V2500-A1/A5/D5 SERIES PROPULSION SYSTEMS SERVICE BULLETIN

This document transmits Revision 2 to Service Bulletin EV2500-75-0091 and the Initial Issue of the Supplement

V2500-ENG-75-0091

ENGINE – LP TURBINE – RELEASE OF SALEABLE DETAIL PARTS FOR ACC DUCT REPAIR

Connector Tube Assembly – Replacement of Connector Tube
Fig.1 (Sheet 1 of 3)

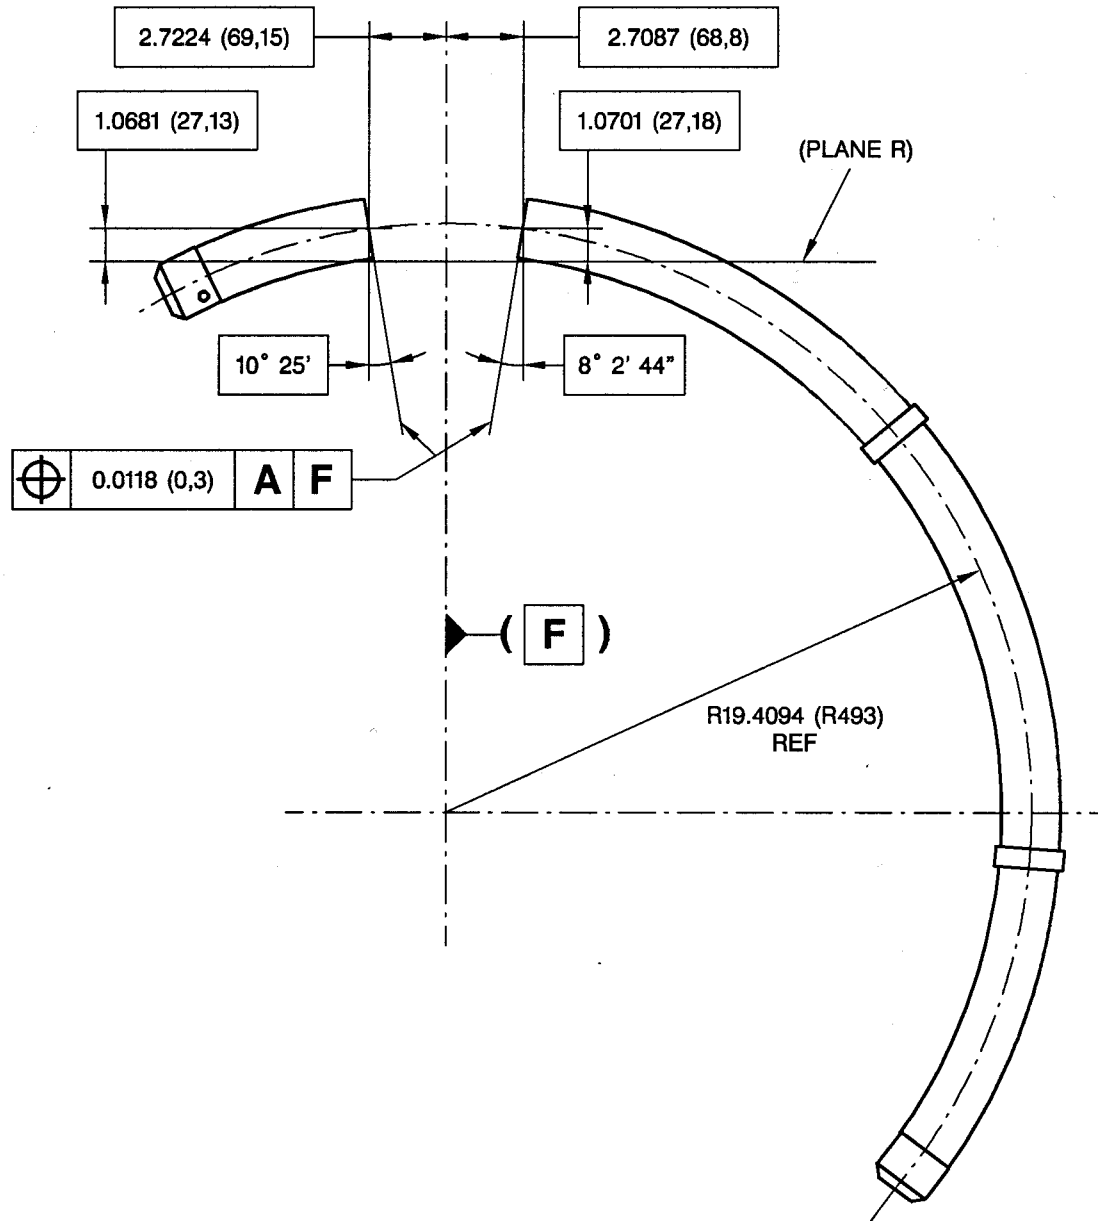
| (3) Remove the Connector Tube | Refer to Fig 1 (sheet 1 of 3) . Use applicable machining equipment and IAE 3M14523 cut off and welding fixture 1 off. |

Connector Tube Assembly – Replacement of Connector Tube
Fig.1 (Sheet 2 of 3)

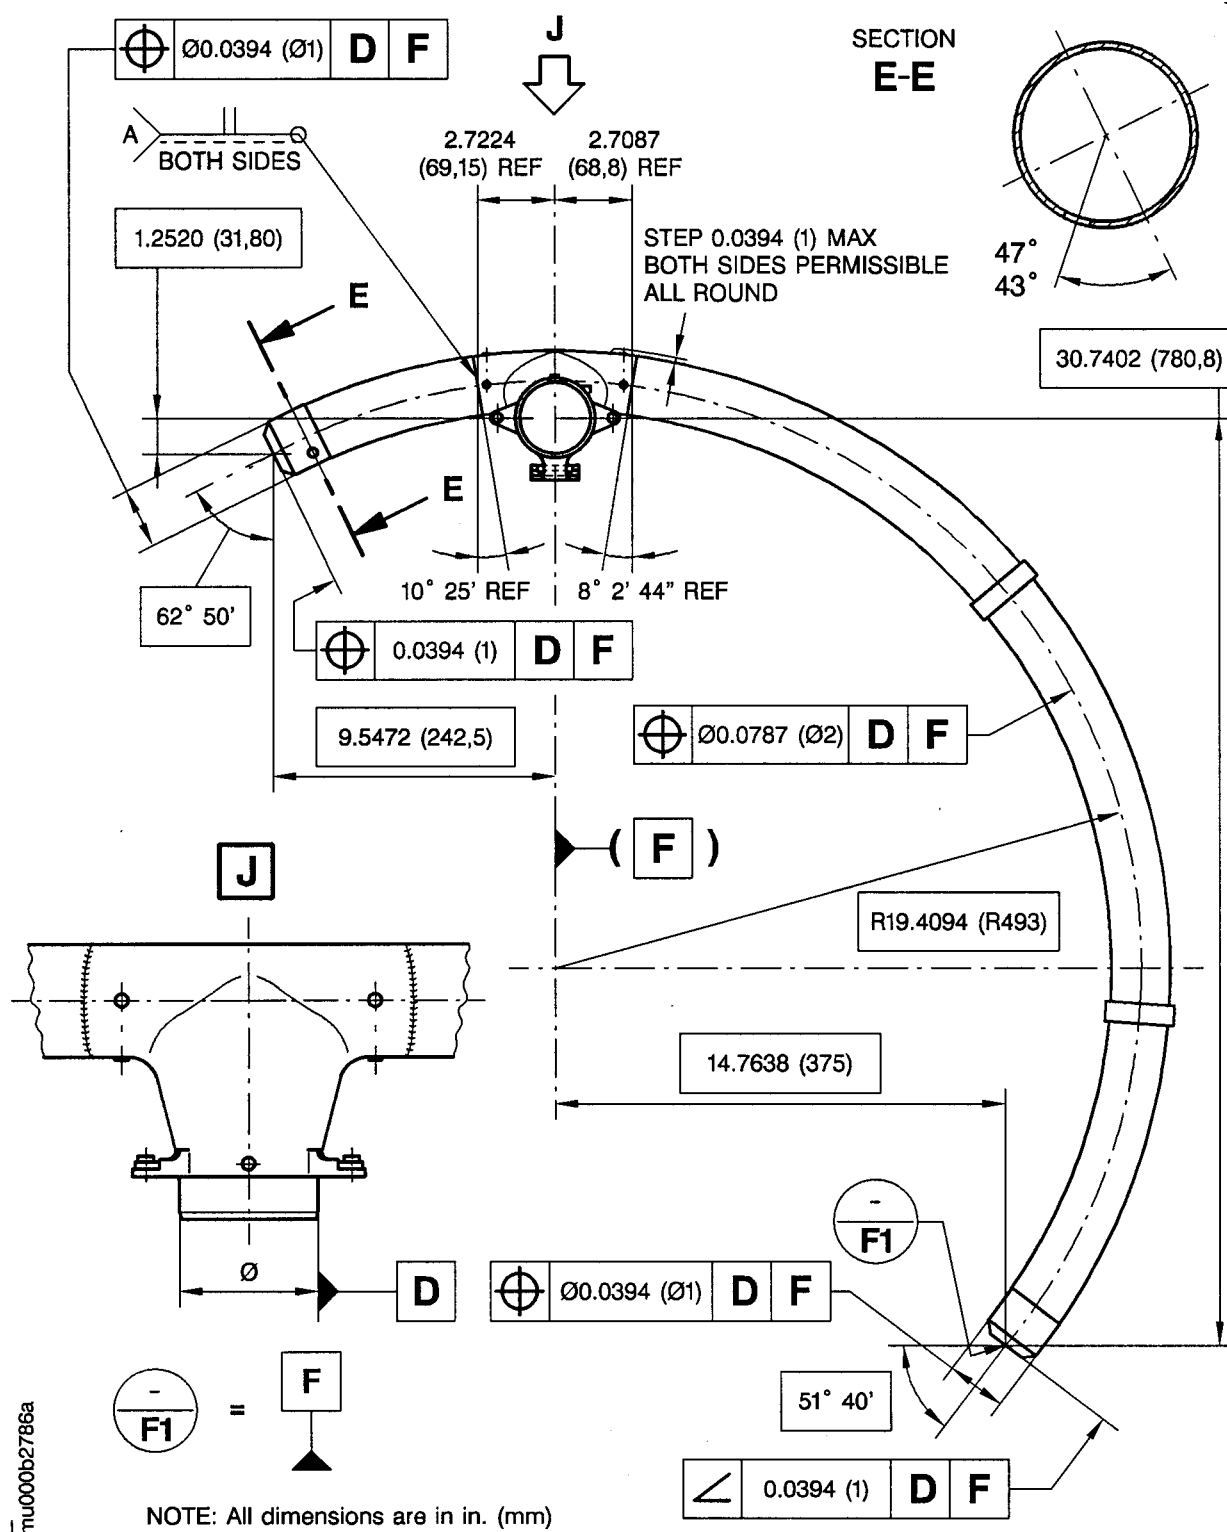
| (4) Examine the machined area | Refer to Fig. 1 (sheet 2 of 3). Use applicable inspection equipment |

Connector Tube Assembly – Replacement of Connector Tube
Fig.1 (Sheet 3 of 3)

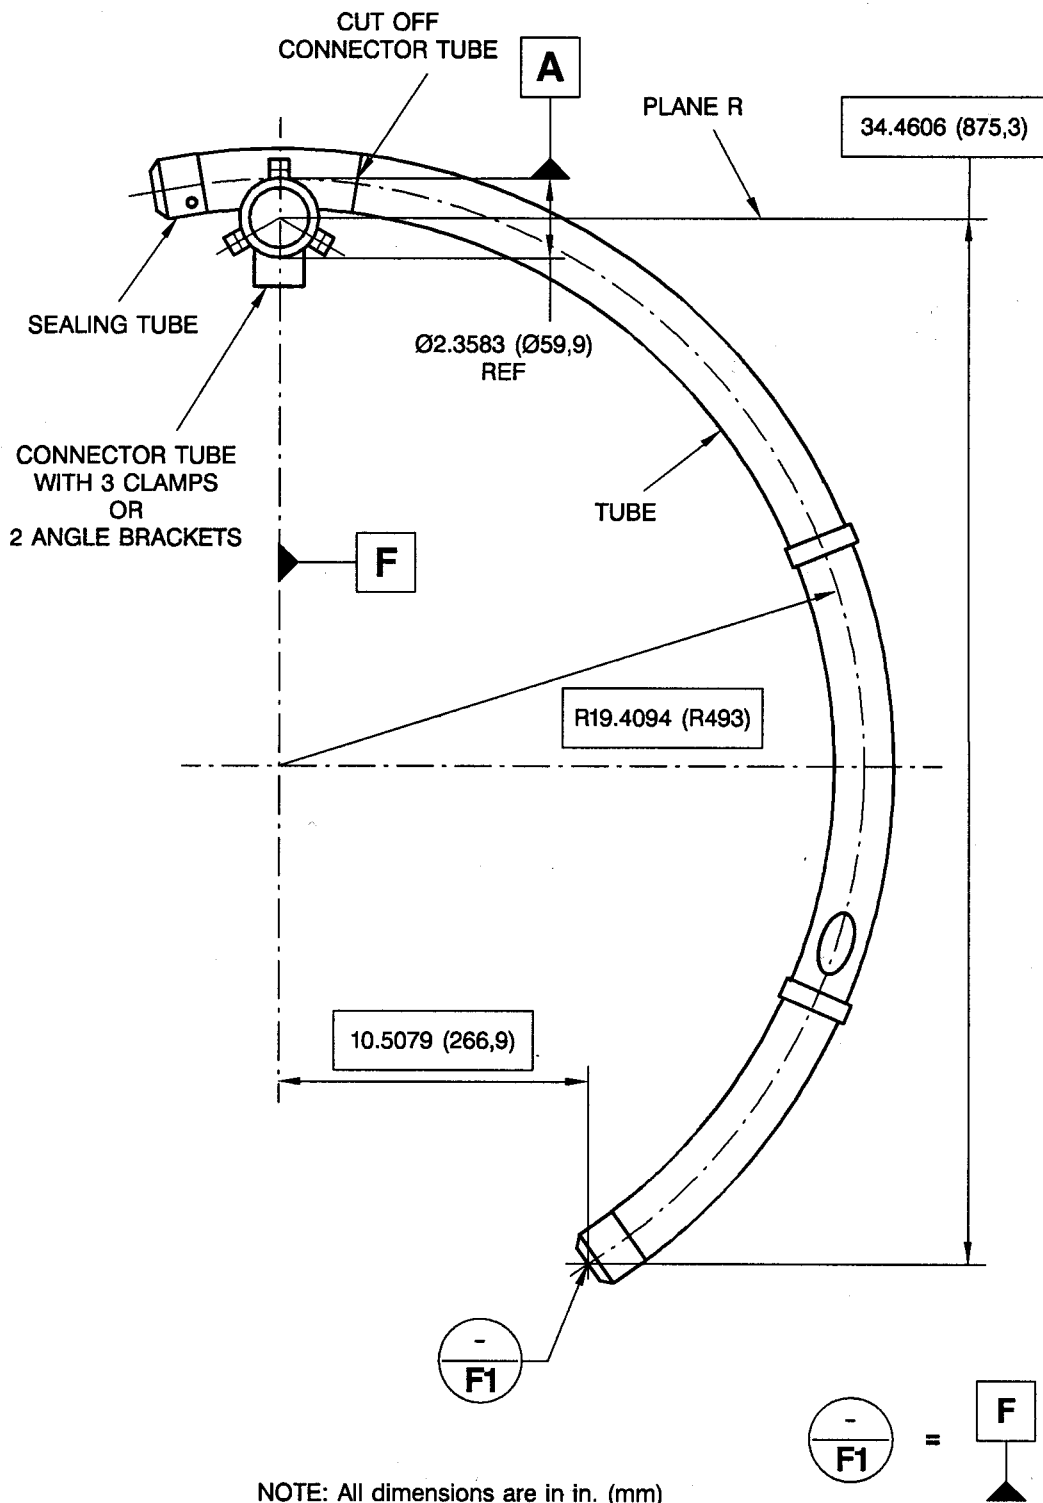
| (6) Weld in the replacement Connector Tube (01-840) to the Connector Tube Assembly | Refer to SPP TASK 70-31-13-310-501 and Fig 1 (sheet 3 of 3). Provide an argon gas backup. Flow argon gas in to the tube during the weld repair. Weld in a protective atmosphere. Use CoMat 03-246 welding material and IAE 3M14523 cut off and welding fixture 1 off. |

| (7) Weld the Cut Tube Assembly to the Connector Tube Assembly | Refer to SPP 70-31-13-310-501 and Fig 1 (sheet 3 of 3) . Provide an argon gas backup. Flow argon gas into the tube during the weld repair. Weld in a protective atmosphere. Use CoMat 03-246 welding material and IAE 3M14523 cut off and welding fixture 1 off. |
| (10) Examine the welded areas dimensionally | Refer to Fig 1 (sheet 3 of 3). Use applicable inspection equipment |

Connector Tube Assembly – Replacement of Connector Tube
Fig.2 (Sheet 1 of 4)

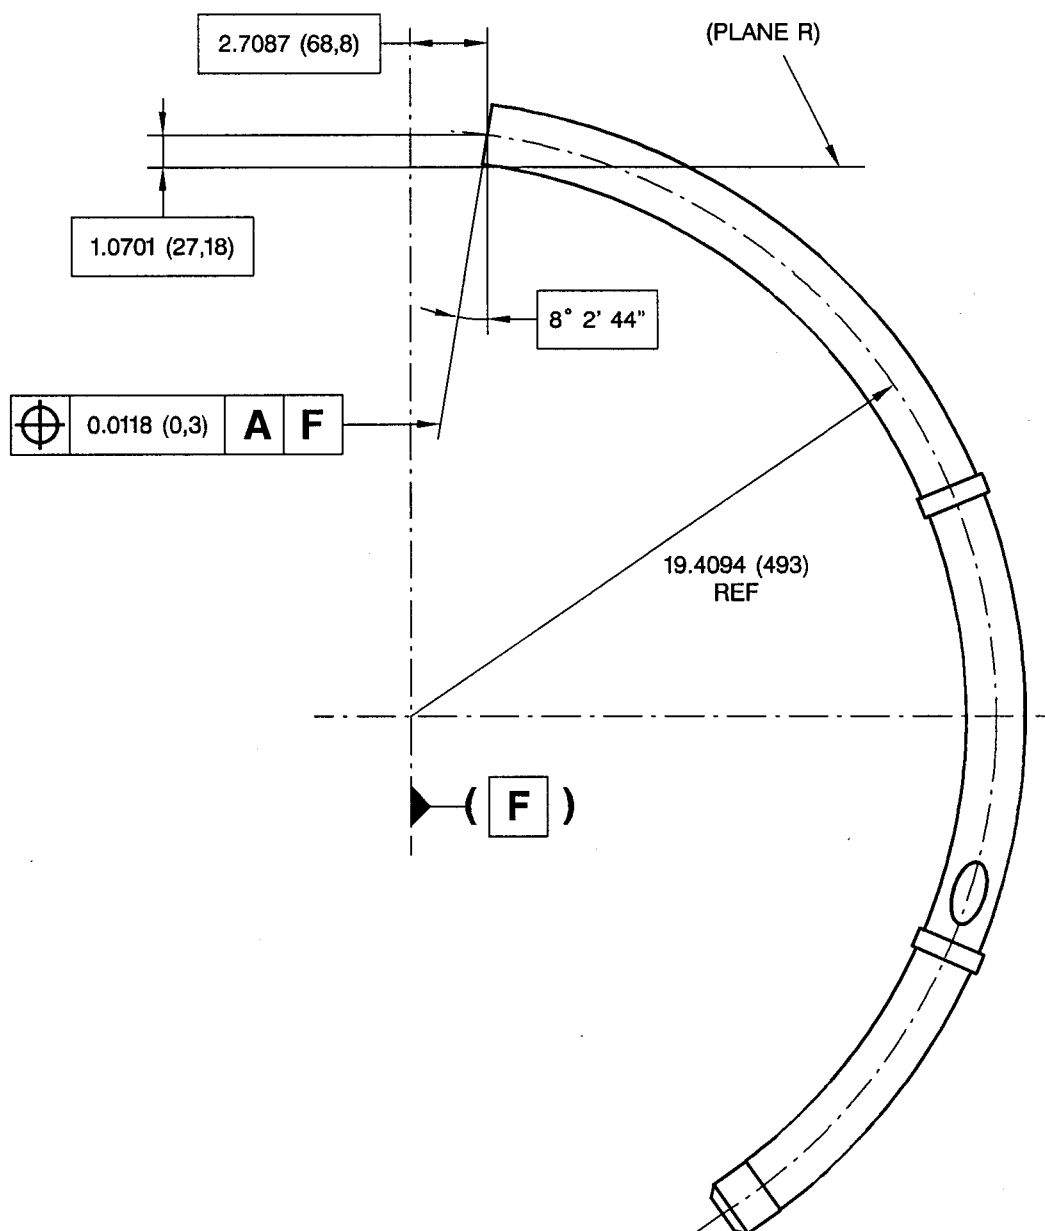
PROCEDURE	RELATED DATA
(3) Remove the damaged Connector Tube	Refer to Fig 2 (sheet 1 of 4) . Use applicable machining equipment and IAE 3M14523 cut off and welding fixture 1 off.

Connector Tube Assembly – Replacement of Connector Tube
Fig.2 (Sheet 2 of 4)

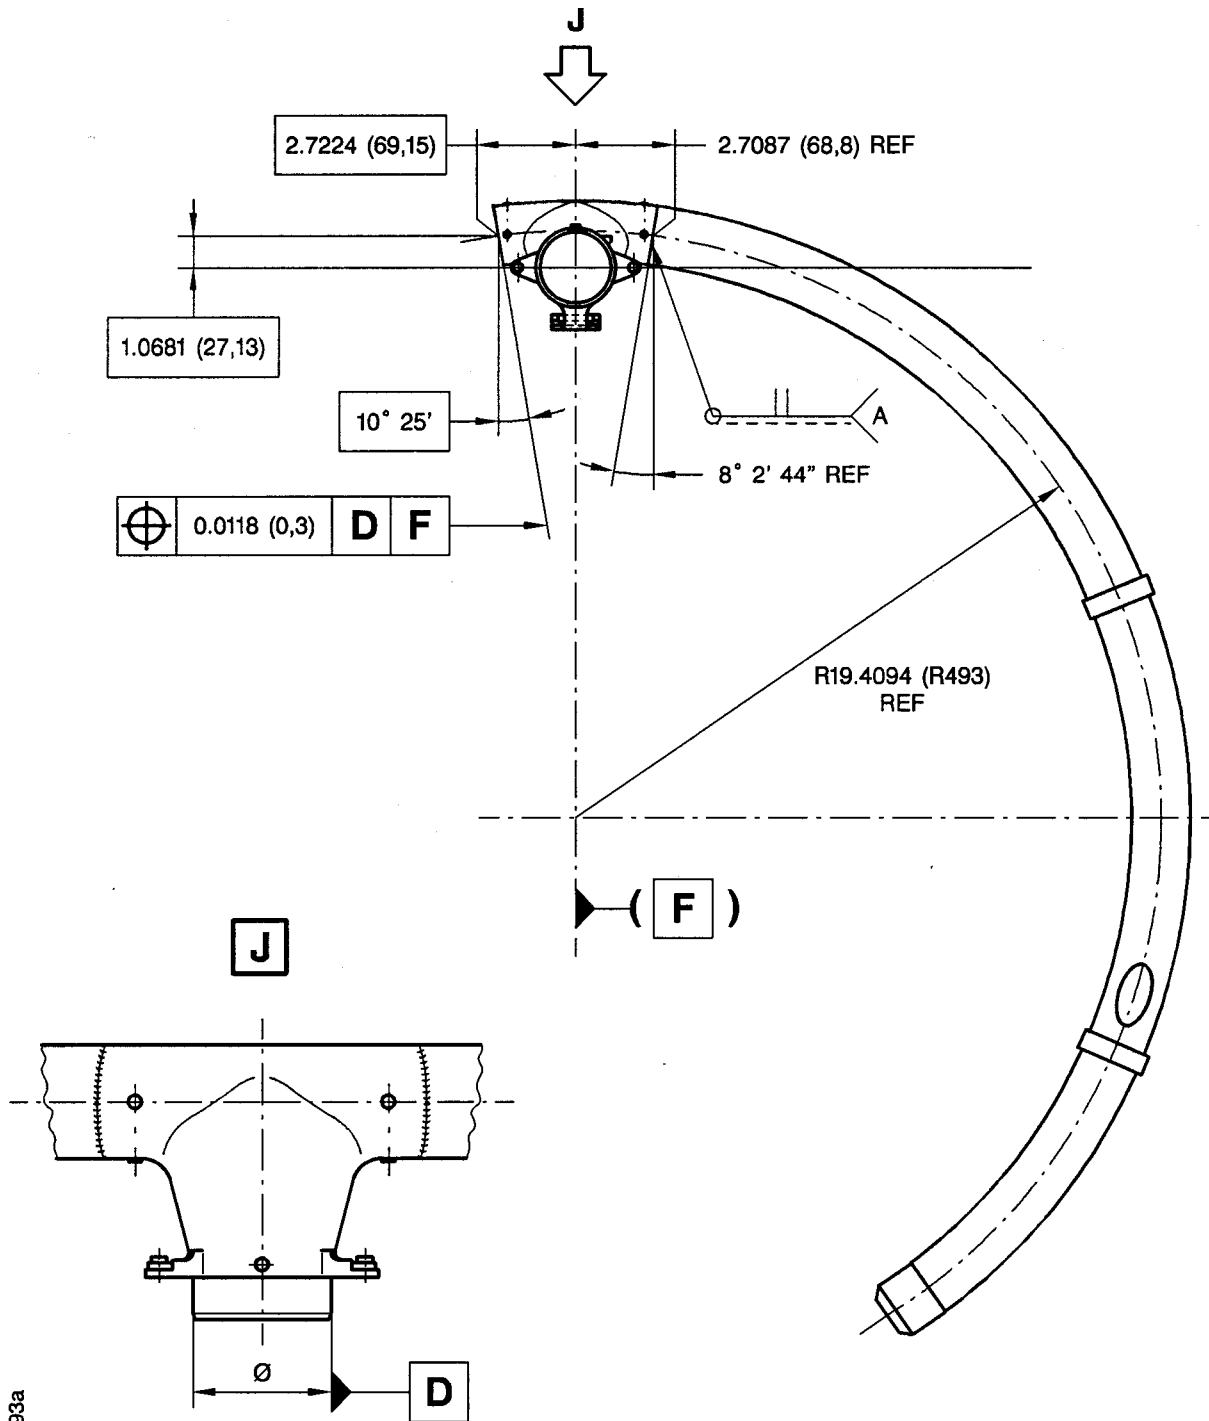
(4) Examine the machined area dimensionally	Refer to Fig. 2 (sheet 2 of 4). Use applicable inspection equipment
(5) Clean the surfaces to be welded	Refer to SPP TASK 70-11-34-300-503

Connector Tube Assembly – Replacement of Connector Tube
Fig.2 (Sheet 3 of 4)

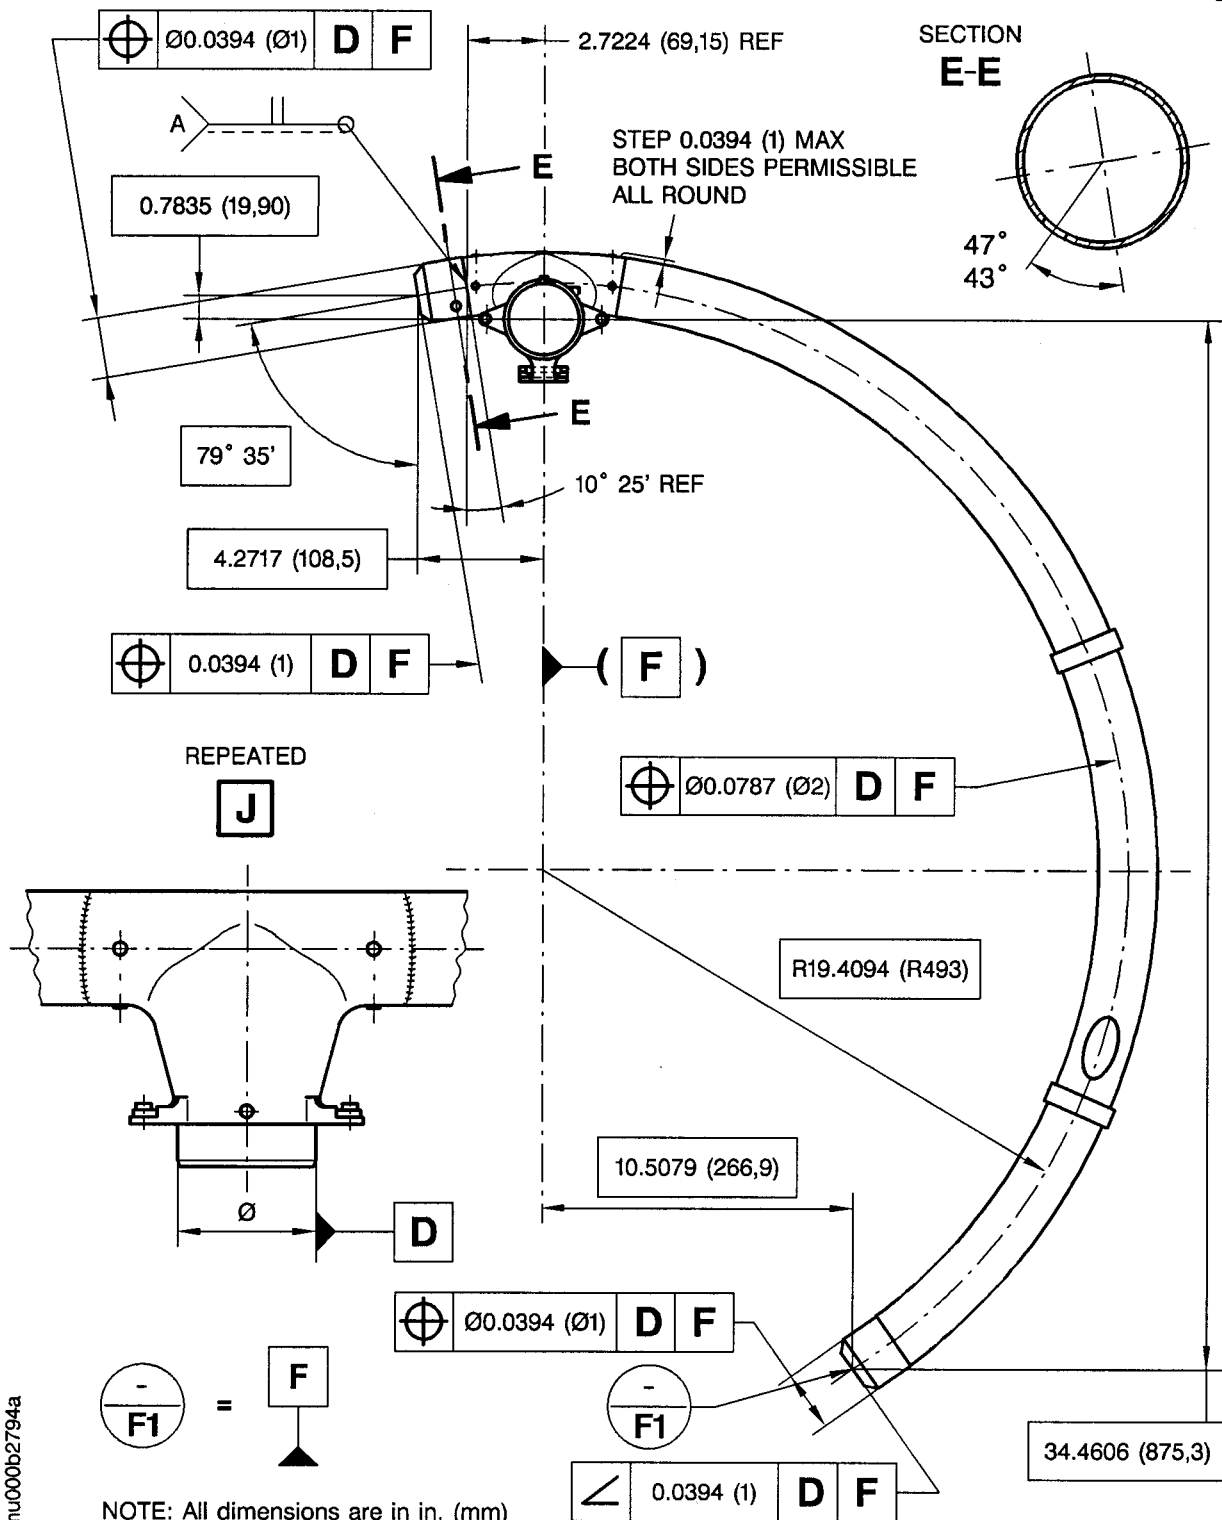
(6) Weld in the replacement Connector Tube (01-840) to the Connector Tube Assembly	Refer to SPP TASK 70-31-13-310-501 and Fig 2 (sheet 3 of 4). Provide an argon gas backup. Flow argon gas in to the tube during the weld repair. Weld in a protective atmosphere. Use CoMat 03-246 welding material and IAE 3M14523 cut off and welding fixture 1 off.
